## **RESIDENTIAL PLAN CORRECTION LIST**

*2016 California Residential Code and West Covina Municipal Code.*

# City of West Covina California Residential Code Wall Bracing Guidelines

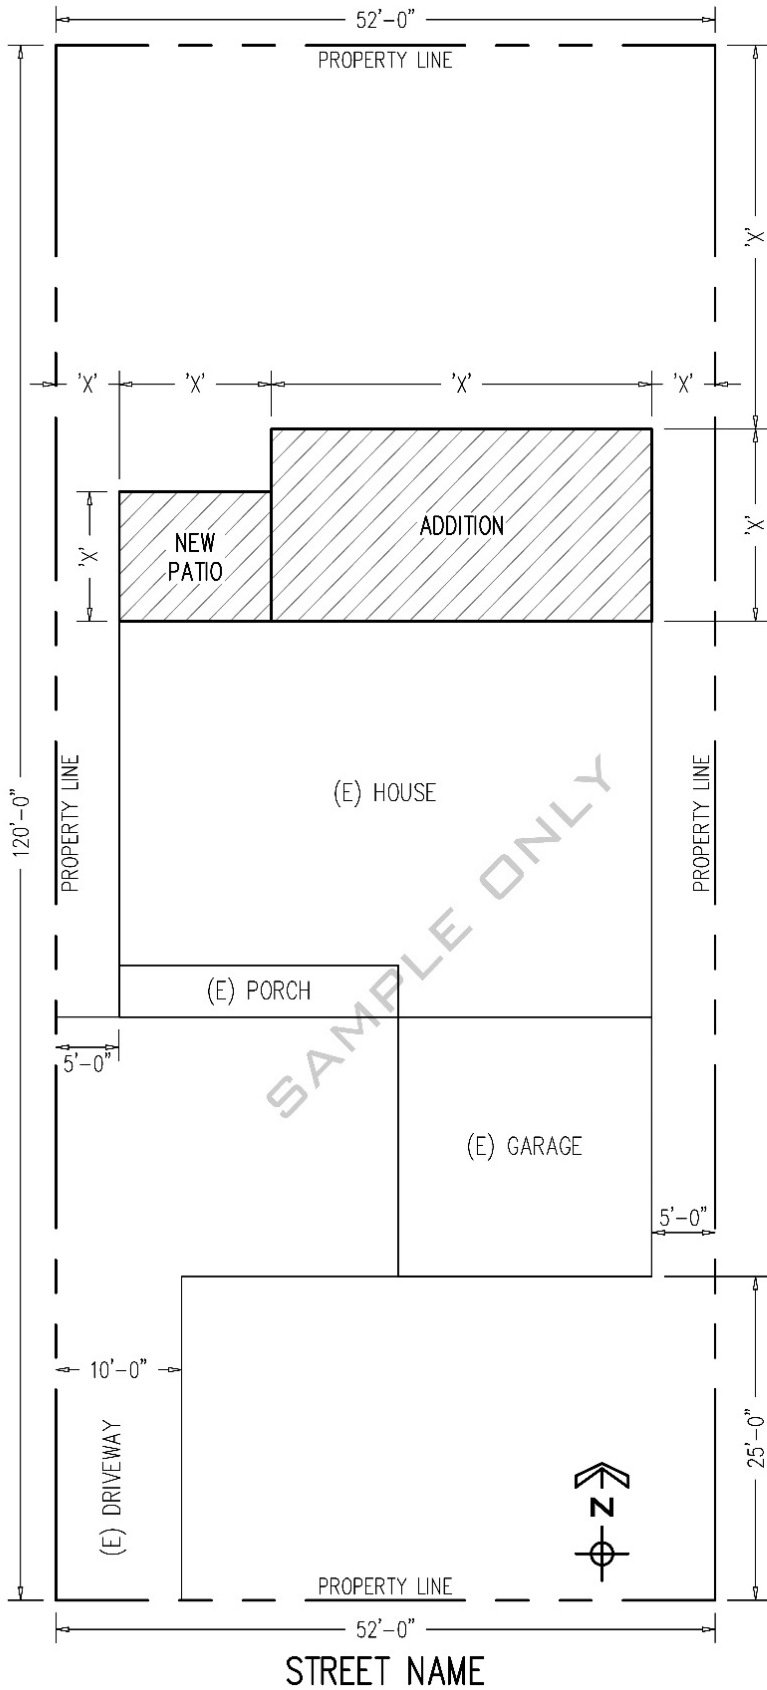
- c. Relocate brace wall panels to start at no more than 8'-0" from building corners.
  - d. Provide minimum lengths per the attached **City of West Covina California Residential Code Wall Bracing Guidelines**.
